STAFF REPORT

APPLICATION RZ/FDP 2011-PR-018

CONCEPTUAL DEVELOPMENT PLAN FINAL DEVELOPMENT PLAN VIENNA MOOSE LODGE

BMP AND SWM COMPUTATIONS

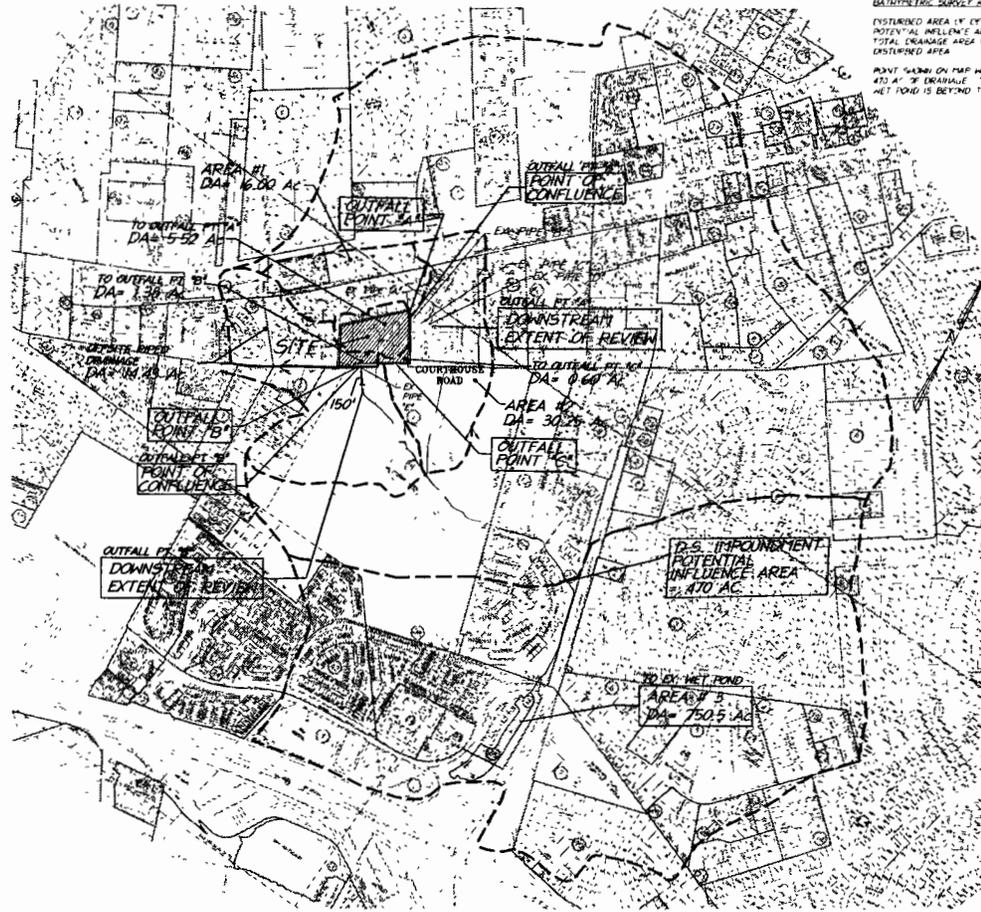
Applicant indicates on sheet 10 that the stormwater detention requirements will be met by an extended detention dry pond with an approximate storage capacity of 14,000 cubic feet with an impoundment area of 0.16 acres proposed to be located in the northeast corner of the property. The final design on the Site Plan must include appropriate details and documentation of the capacity and function of the facility, and calculations of the release rates (e.g., more than just the storage volume), and demonstrate compliance with the detention requirement.

A dam breach narrative has been provided in sheet 10 of the CDP which commits to a detail dam breach analysis during final design. The narrative mentions that the sunny day dam failure will not have any impact on the downstream residential development. This is reported to be based on preliminary analysis. No detail has been provided. The overtopping dam breach path is reported to follow the area between lot 4 and 5, Lemontree Lane, down to Courthouse Road and to channel in Nottoway Park. The applicant shall demonstrate through a detail dam breach analysis that the existing houses downstream of proposed pond are not adversely affected by the dam breach inundation zone. Without this analysis, it is not certain if, or to what extent remediation efforts will be necessary on lots 4 and 5.

The applicant has proposed to meet the phosphorus removal requirement by use of proposed extended detention dry pond, a porous paver and a filterra as shown on sheet 10 of the application. With less than 20% increase in impervious area, the proposed development qualifies as redevelopment. The phosphorus removal requirement is 24.6 %, however the applicant has volunteered to provide 29.91% as shown on sheet 10. The staff believes that a 30% phosphorus removal requirement should be placed as a development condition to ensure and enhance the water quality and remove any confusion during site plan approval.

Figure 4: Source: Christopher Consultants

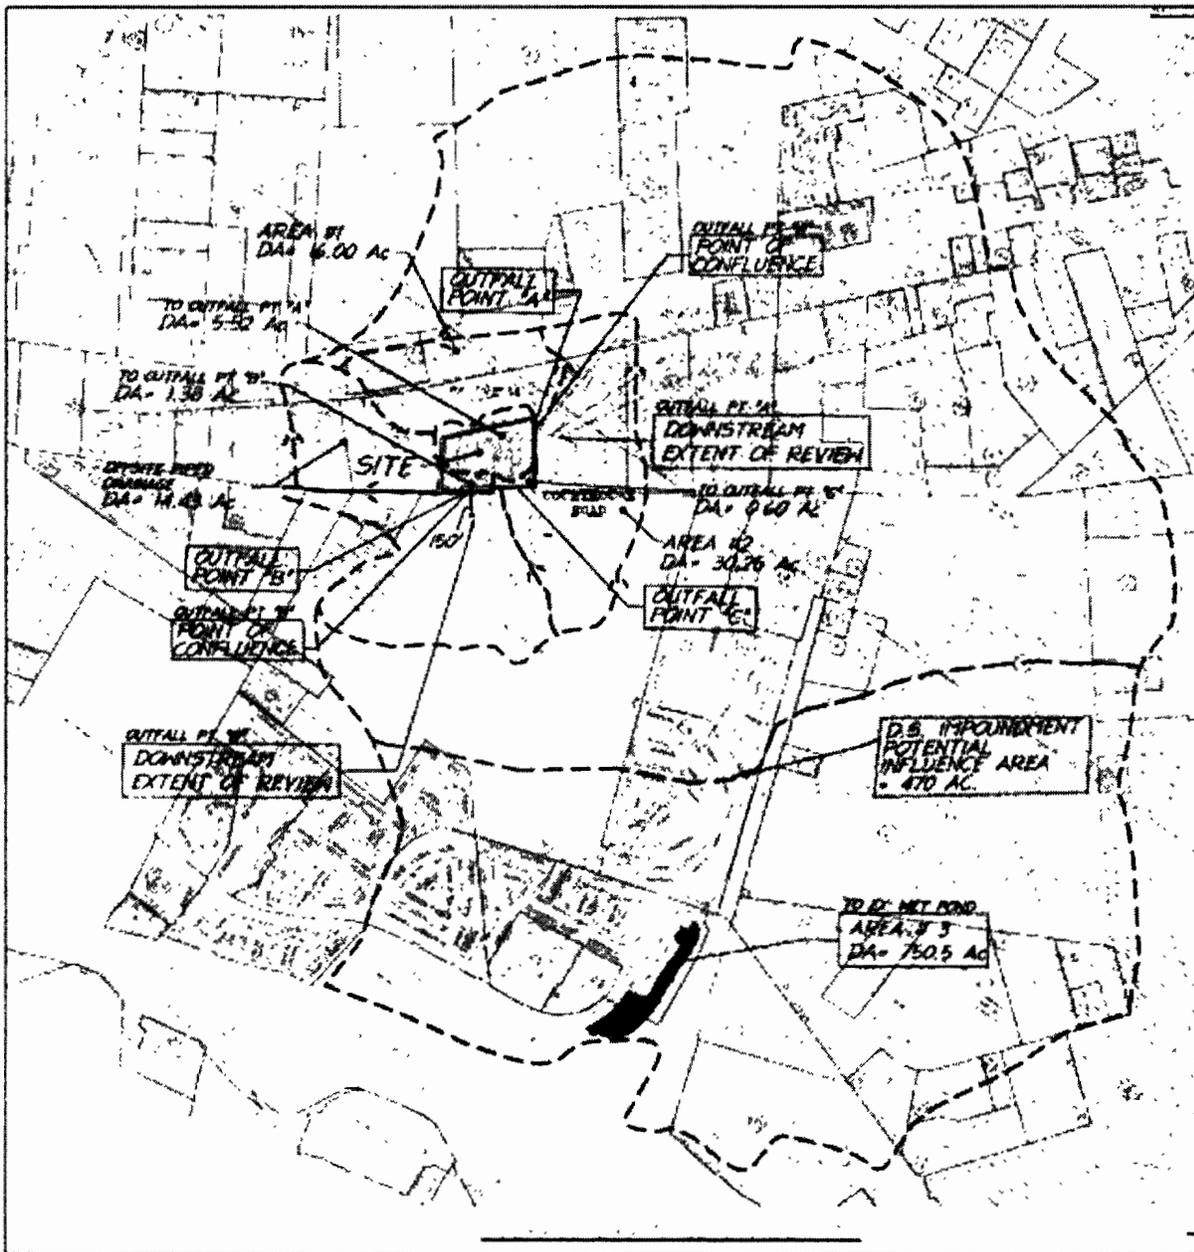
Outfall narratives and analysis have been provided on sheet 11 for three outfalls shown as Outfalls A, B and C. All three outfalls appear to have met the current Public Facilities Manual (PFM) requirement of adequate outfall. The extent of downstream drainage analysis for Outfall B has been shown to be ending at 150 feet downstream of Courthouse Road. Based on the initial analysis, the applicant has shown no adverse impact and proportional improvement by "The Critical Shear Stress" method of PFM by reducing the drainage area captured by this Outfall B.

Outfall narratives and analysis have been provided on sheet 11 for three outfalls shown as outfalls A, B and C. All three Outfalls A, B, and C appear to have met the current PFM requirement of adequate outfall. On revised sheet # 11 dated March 12, 2013; the extent of downstream drainage analysis for outfall B has been shown to be ending at 150 feet downstream of Courthouse Road. Based on the initial analysis, the applicant has tried to show no adverse impact and proportional improvement by "The Critical Shear Stress" method of PFM by reducing the drainage area captured by this out fall B.
